CHANCE
MANUFACTURING CO., INC.

Service Information

Ride: TWISTER

Subject: INSTALLATION OF RESTRAINING BELTS

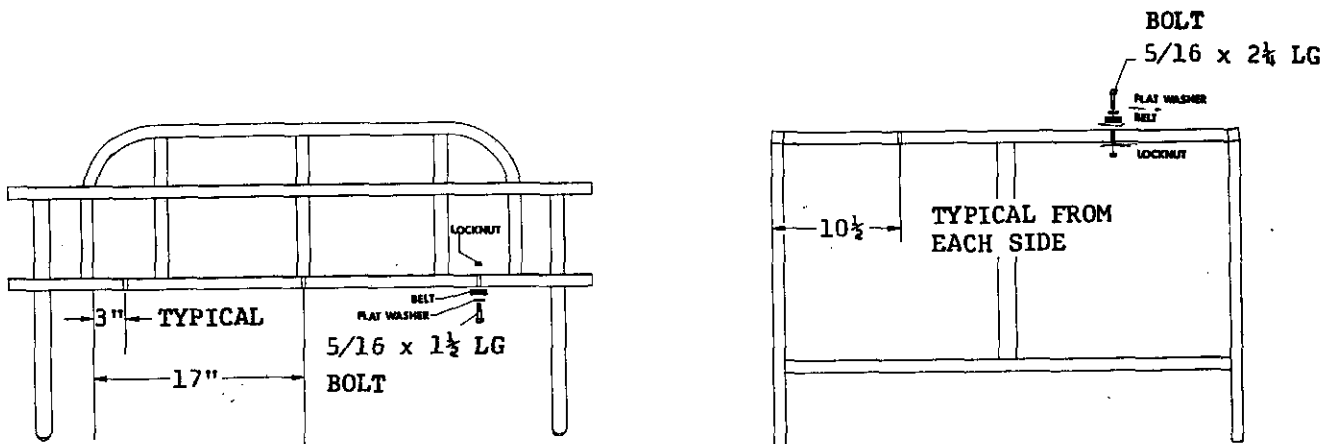
1. Remove the headrests from the cars and drill three 5/16" diameter holes in each one as shown.
2. Install 5/16 x 1½ LG bolt, flat washer and restraining belt from bottom side of tube on the headrest and secure with locknut.
3. Drill two 5/16" diameter holes down thru the square tube that supports the back of the front seat of each car.
4. Install 5/16 x 2¼ LG bolt, flatwasher and restraining belt from top side of tube and secure with locknut.

When installing belts make sure they are not twisted before bolting.

Subject: Floor lift cylinder-structure addition.

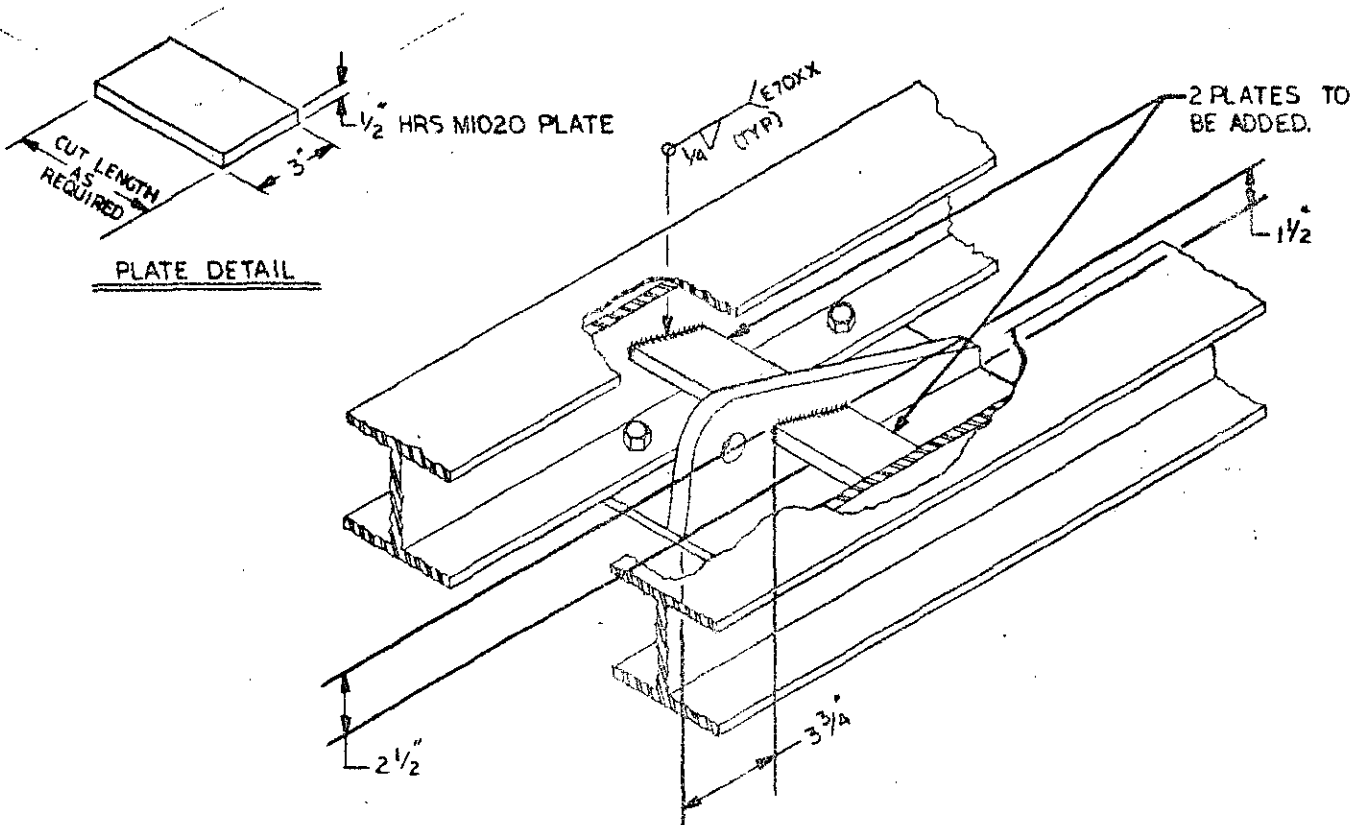
In order to improve the structure of the floor lift beam cylinder mounting bracket, we ask that the following change be added to both floor lift beams. Weld two $\frac{1}{2}$ " steel plates, one to each side of the hydraulic cylinder mount, in accordance with the dimensions shown in the detail section. Ride owner to furnish plates to be added.

Subject: Trailer Reinforcement

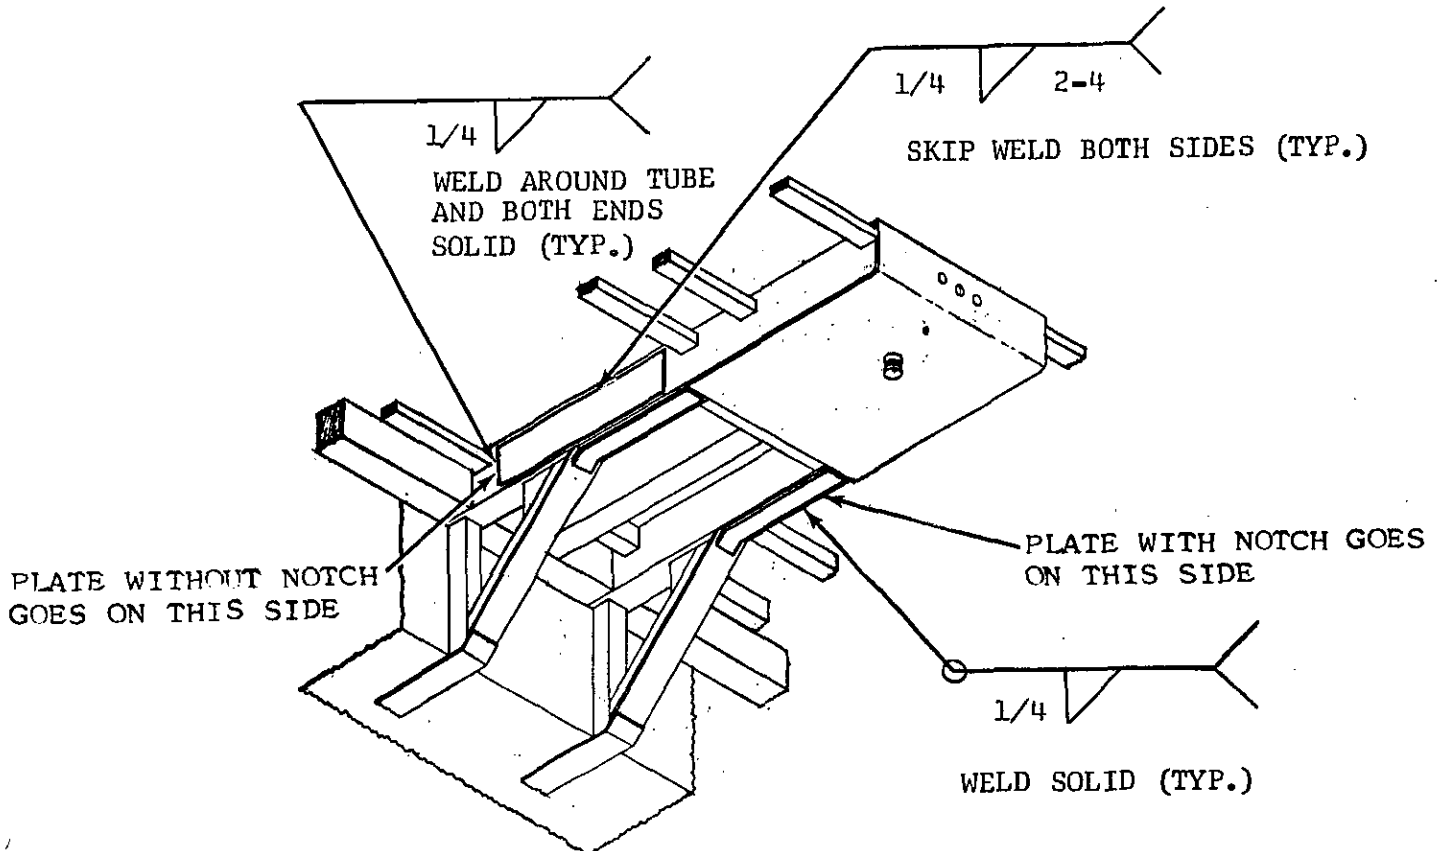
We wish to inform all Twister owners of an area on the Twister trailer that could be termed marginal as far as strength goes. Should the trailer become bogged in mud and you try to jerk it free, it is possible that the main support tubes could bend. This could also happen if the trailer were bouncing severely on a rough highway. Enclosed is a print showing details of some plates. We are recommending that these plates be added to the trailer immediately. The print calls for 3/8" thick plate and this is recommended. However, if the 3/8" plate is not available, 1/4" plate could be substituted.

Subject: HEAD REST INSPECTION

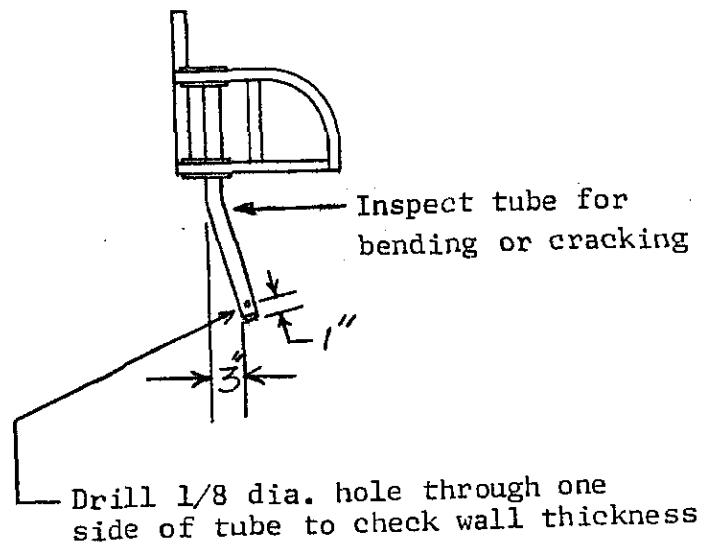
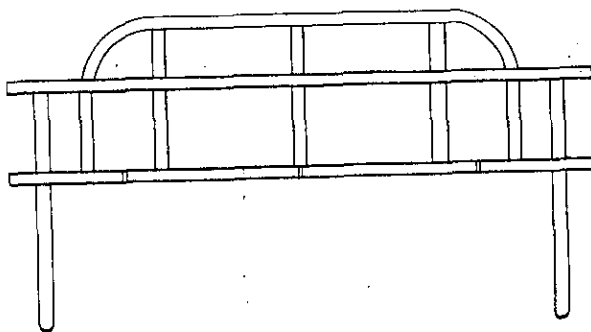
We are asking all TWISTER owners to inspect the head rests on all TWISTER cars immediately. Remove each head rest and inspect the support tubes that fit down in the sockets on each car. Inspect for any signs of physical damage, such as bending or cracking. Next, drill a small hole, 1/8 inch, near the bottom of the support tube approximately 1 inch from bottom. Drill hole through one side of tube only. Check wall thickness of tube. It should be 1/8 inch thick.

If any of the tubes show signs of bending or cracking, or if any tube has less than a 1/8 inch wall, report such condition to Mr. Richard G. Chance, General Manager, Chance Manufacturing Company.

Subject: INSTALLATION OF CONTROL
LEVER DETENT

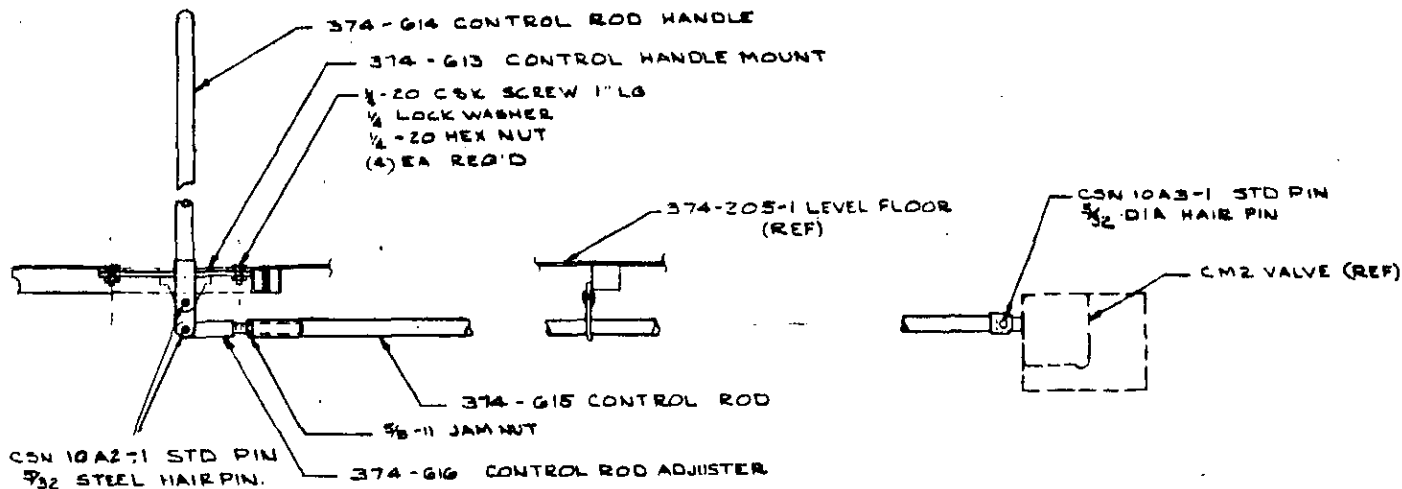
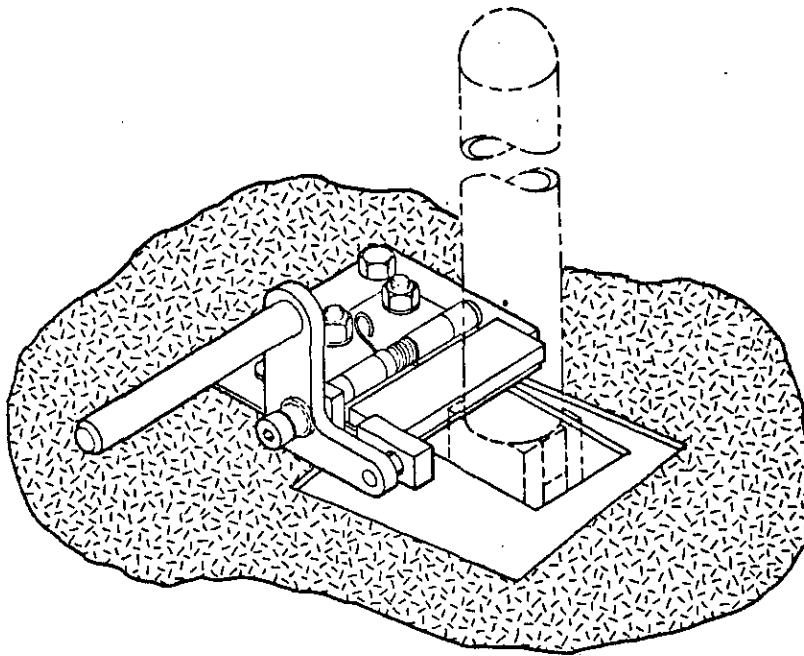
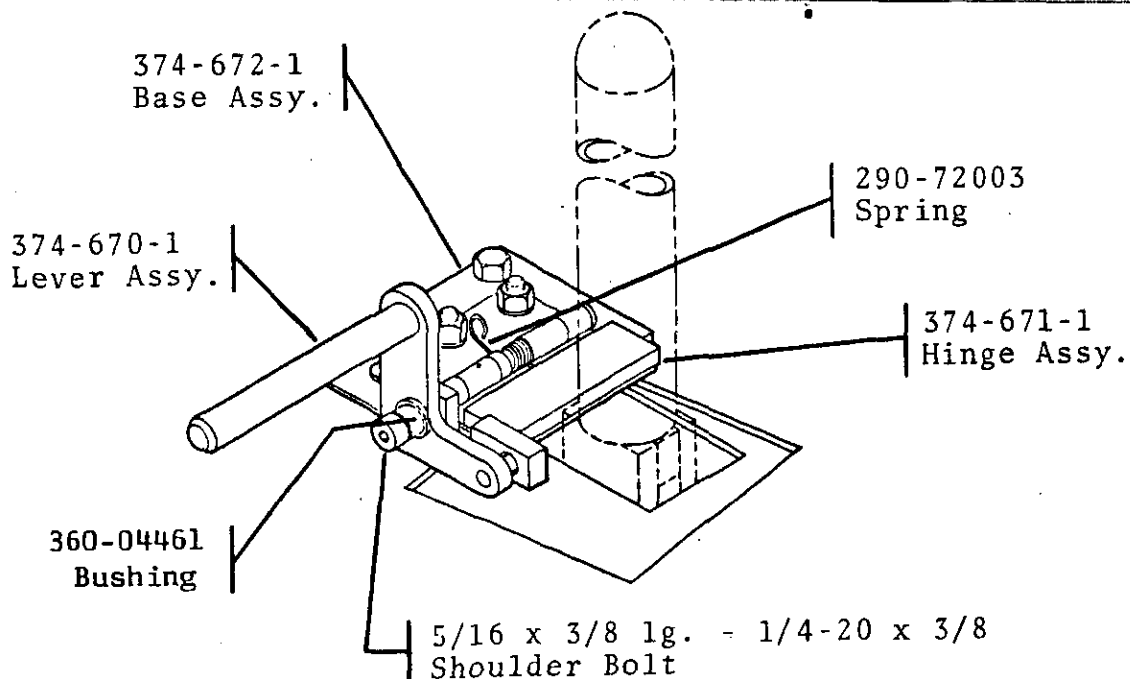
Before installing the detent, the Control Rod Handle should be adjusted so it is in a vertical position.

To adjust handle, loosen the jam nut and adjuster on the control rod underneath the porch. Turn adjuster until Control Handle is vertical and tighten jam nut.

Position Detent Assembly in front of the Control Handle, centering it with the travel of the Handle.

If there is any slop or play in the travel of the handle, push it forward gently until it is at the point of engaging the control valve.

Now, position the detent so that it is up against the Control Handle

Mark and drill holes to match Detent Base Plate, securing with bolts provided.

Ride: TWISTER
Serial Numbers 73-3201 thru 74-3218 Subject: BRAKE RELIEF VALVE
PRESSURE SETTING

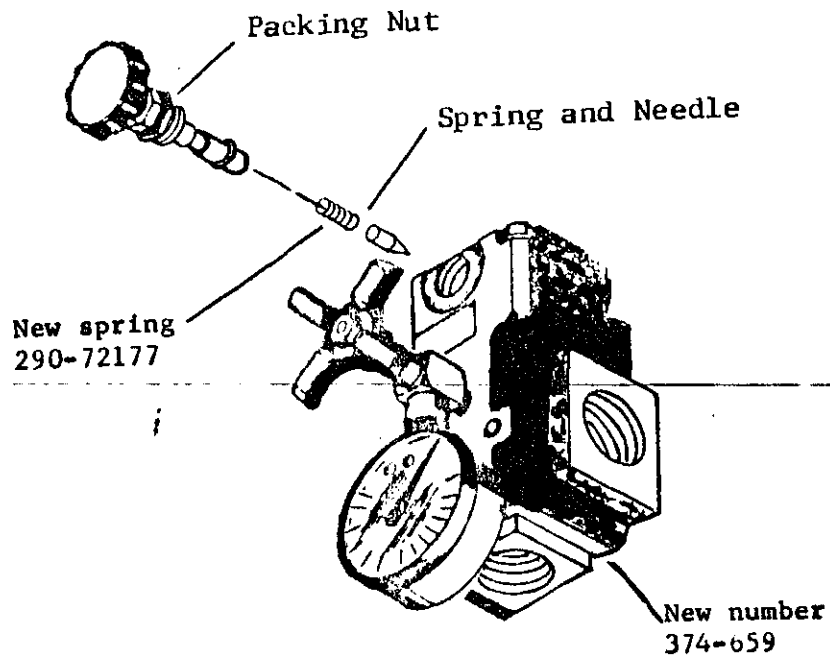
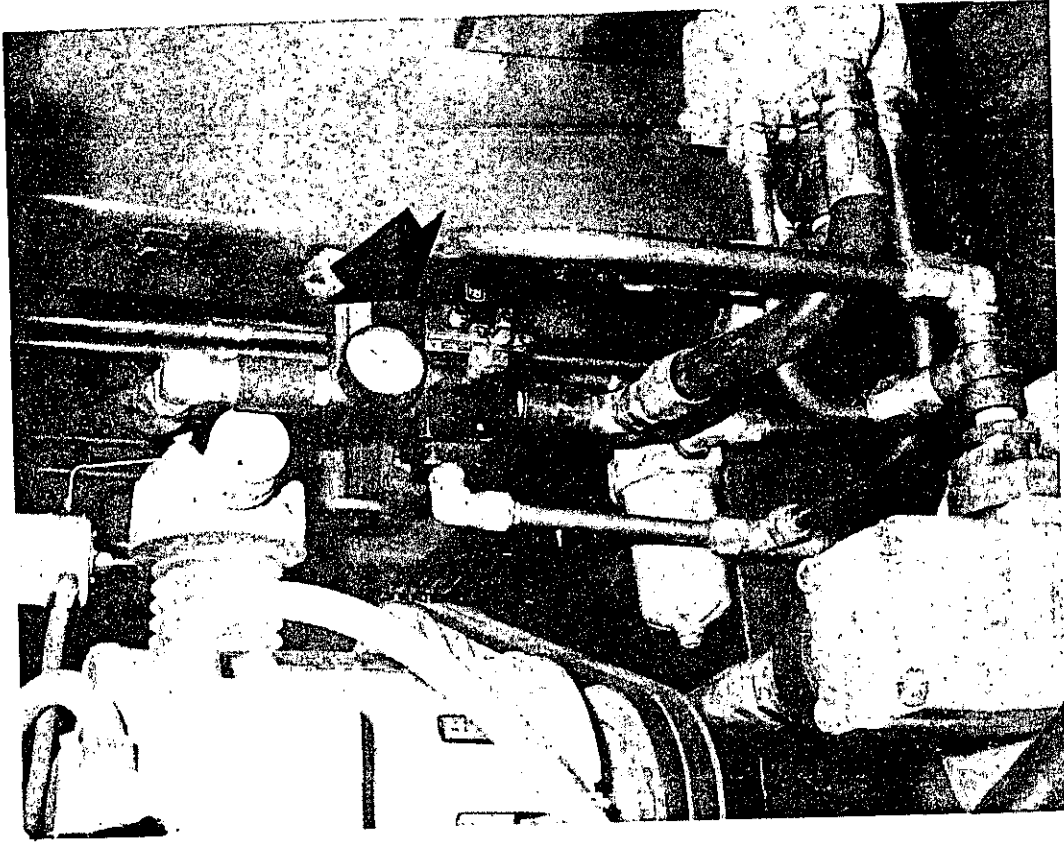
From field observations, it has become apparent that a number of TWISTER Rides are being operated with the "Brake Pressure Relief Valve" set at a higher pressure setting than the recommended 700 P.S.I. maximum.

This results in a severe braking action causing discomfort to ride passengers. In addition, it subjects the ride structure to undue stresses.

To eliminate this, we have enclosed a new spring that is to be installed in the relief valve. This will limit the valve to a maximum setting of approximately 700 P.S.I.

The Relief Valve is readily accessible as can be seen in photograph.

To replace spring, loosen the packing nut behind the Adjustment Knob, and carefully remove Adjustment Knob and Stem.

Replace spring and assemble in reverse order.

Run the ride and adjust Relief Valve to approximately 600-700 P.S.I.

Change Valve callout on pages 36 & 42 of the Twister Manual, from MRFN 12P-0A-P-09AA to 374-659

Subject: CHECKING SWEEP FOR CRACKS

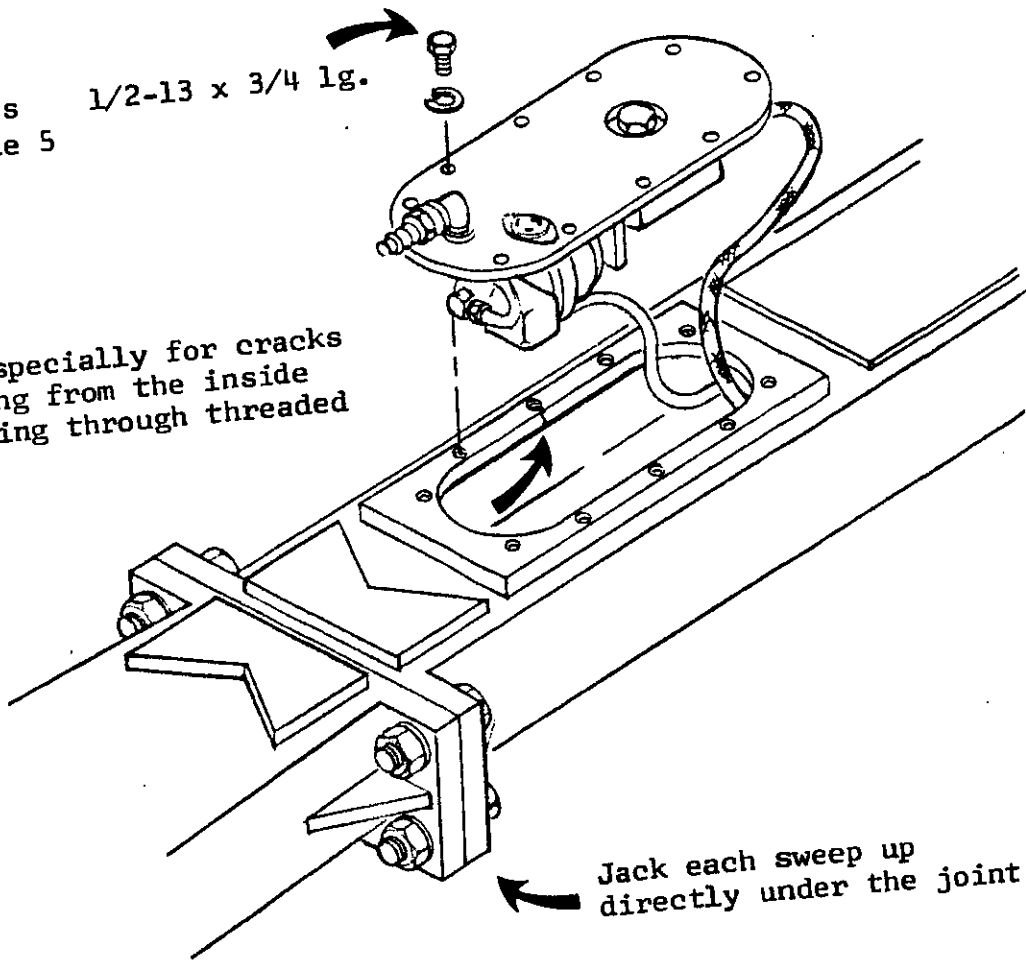
Remove the cover plate * and inspect area around access hole.

Look especially for cracks starting from the inside and going through threaded hole.

If no cracks are found, install cover plates, torquing bolts to 75 ft. lbs.
If bolts are greasy or oily, torque to 55 ft. lbs.

Check length of bolts before installing cover plates. The six bolts along sides should be 3/4 inch long grade 5 bolts. Longer bolts will bottom out against the sweep channel not drawing the cover plate down tight.

SECTION A-A

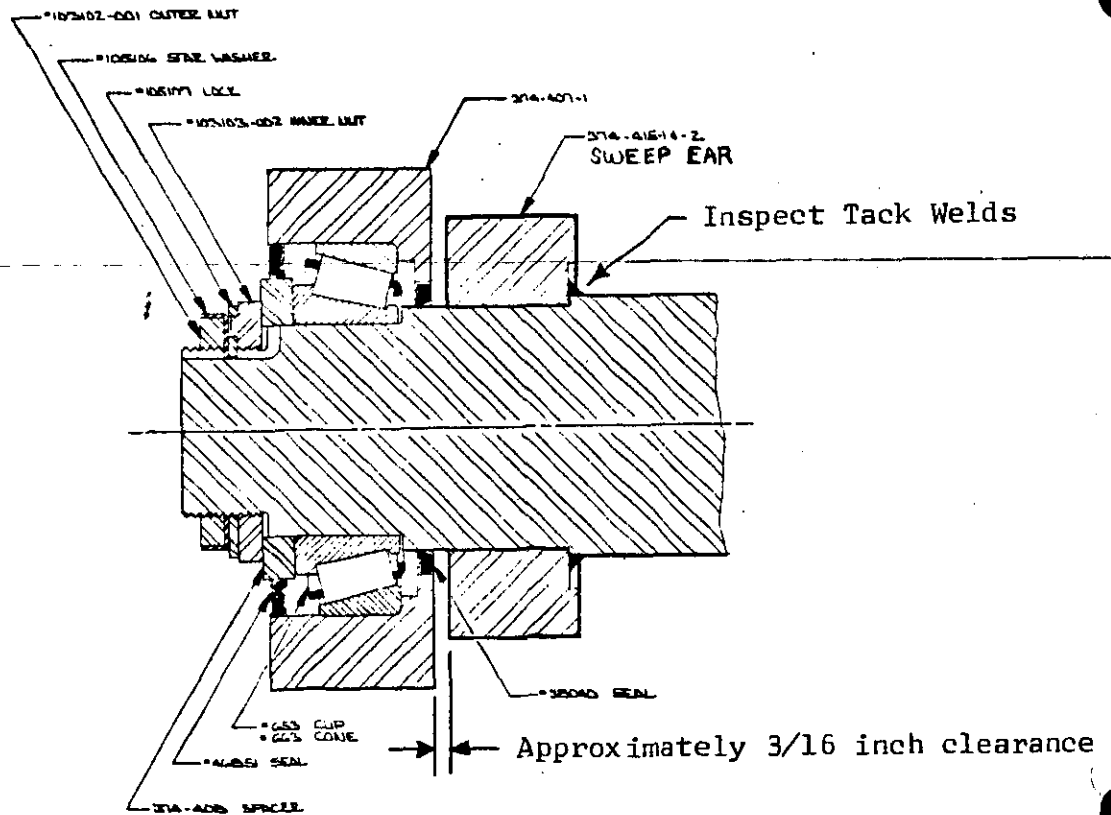
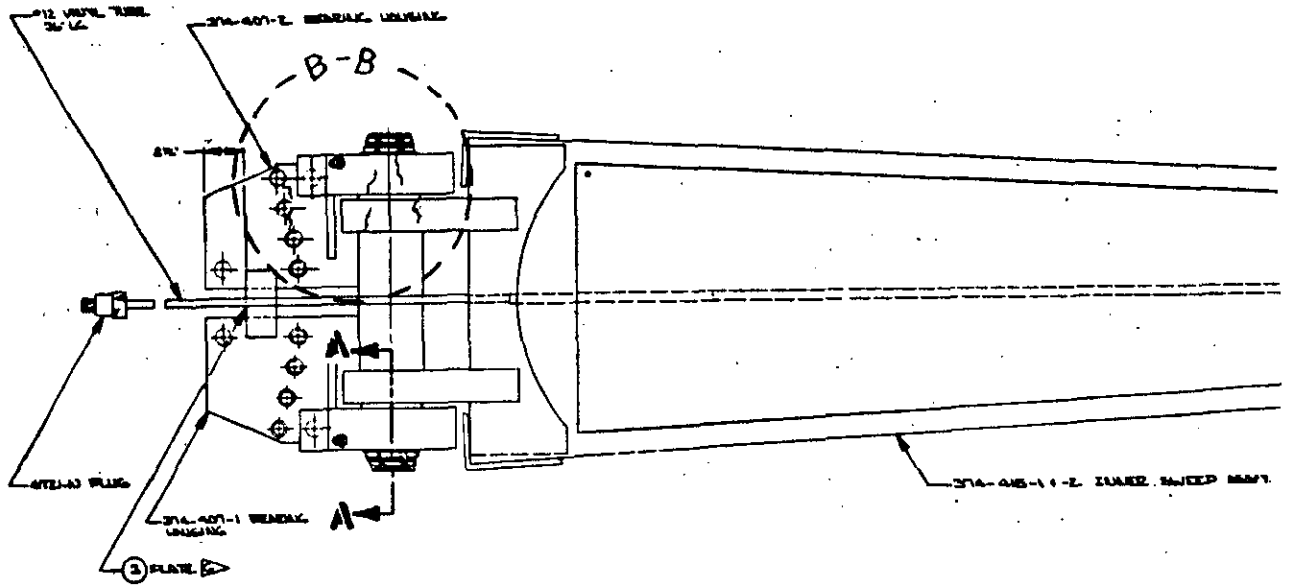
1. Inspect the plate and ears that bolt onto the Center Hub, paying particular attention to the area around the bolt holes. "B-B" and ears that house the Bearings shown in section "A-A".

Look for any signs of cracks in ears, plate or welds. If the ride has recently been painted, look for signs of cracking or stretching in the paint.

2. The sweep shaft is tack welded to the sweep ears as shown in "A-A". Inspect this area very carefully to see if welds are holding.

Also, check clearance between sweep ear and the bearing ear. There should be approximately 3/16 inch between the ears.

Subject: SWEEP REPORT

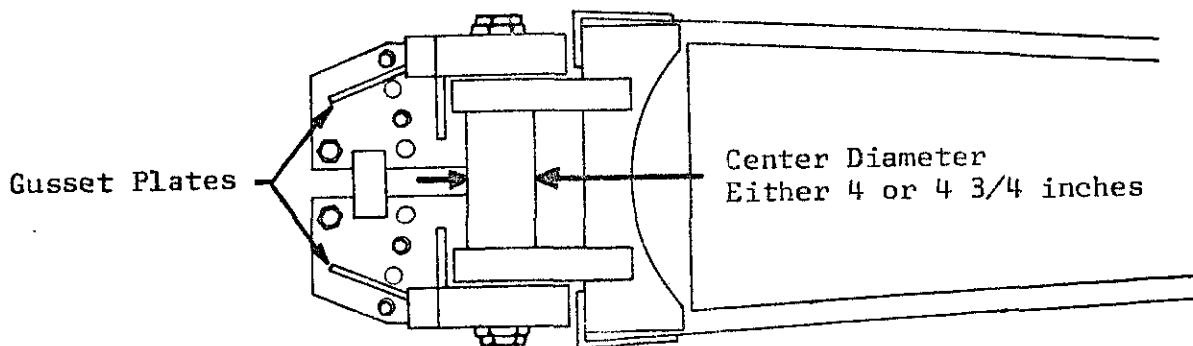
After evaluating the reports on the Sweep joints, Ref. Bulletin 104, it has been determined that it would be desirable to reinforce all existing sweep joints, that haven't already been done.

1. Center diameter of shaft.
2. Bearing housing (does or does not) have gusset plates as shown.
